23/01338/OUM

Outline planning application for the erection of up to 83 Affordable Homes with associated access, parking and landscaping - all matters reserved except for means of access

TITLE: 23/01338/OUM

Committee: Planning Committee

Figure 3.3 – Site Access – Proposed T-Junction

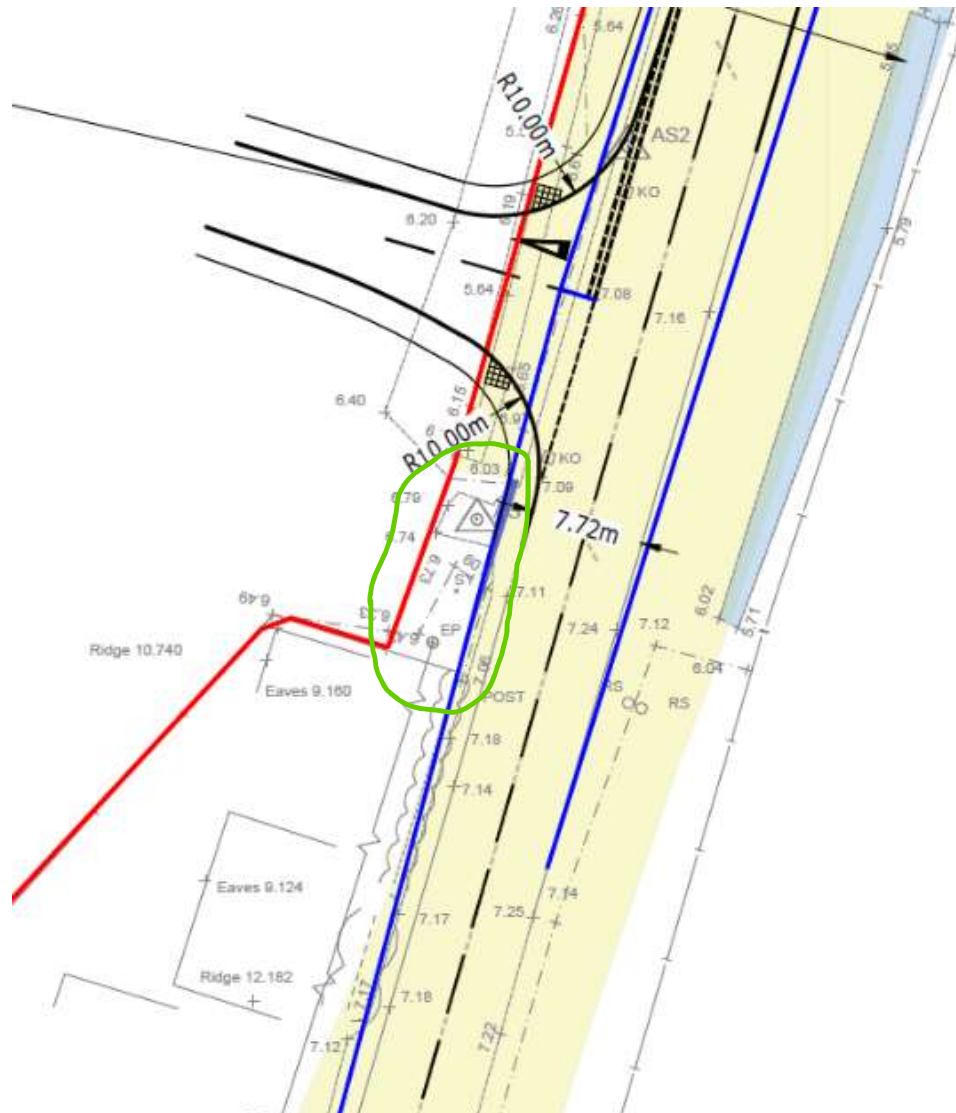
- 3.2.7 Stantec questions whether the 120m visibility splay can be achieved to the right of the proposed site access. The splay is obstructed by further existing vegetation intruding into the highway - as shown in **Figure 3.2** - as well as third-party land. The photo in Figure 3.2 has also been taken 2.4m back from the main carriageway kerbline to mimic the position of a driver waiting to turn.

3.2.8 Whilst Stantec accepts vegetation within the highway may be removed to increase visibility, the site access drawing (2006310-004 Rev B – Proposed Site Access Arrangements – Priority 'T' Junction) does not provide sufficient detail to confirm that the right visibility splay can be provided without potentially needing third-party land, as well as the construction of the footway kerb line (adopted public highway been shown as shaded yellow). The area of land in question is circled green below in **Figure 3.3**, and does not appear to be within public highway or the development red line boundary.

3.2.9 Stantec recommends the Applicant is required to provide further detail of the highway boundary for review to determine whether an appropriate visibility can be achieved without third party land.

Figure 3.4 – Google Maps Typical Traffic Conditions

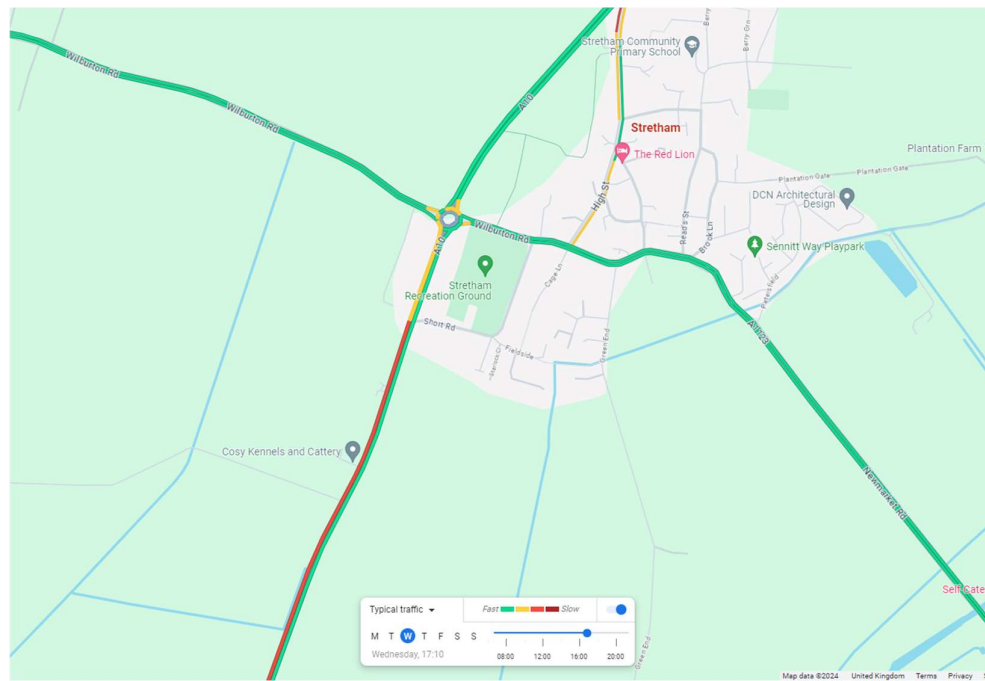
- 3.3.10 The CCC Highways Officer response referred to the A10 / A1123 roundabout peak period congestion leading to queueing traffic on the A10 extending to the proposed site access which could prevent vehicles from exiting / entering the site.
- 3.3.11 The Google Maps typical PM Peak traffic conditions shown in Figure 3.4 shows this.

3.3.12 As conditions at the A10 / A1123 Roundabout were not assessed as part of this Transport Assessment, Stantec is unable to comment further.
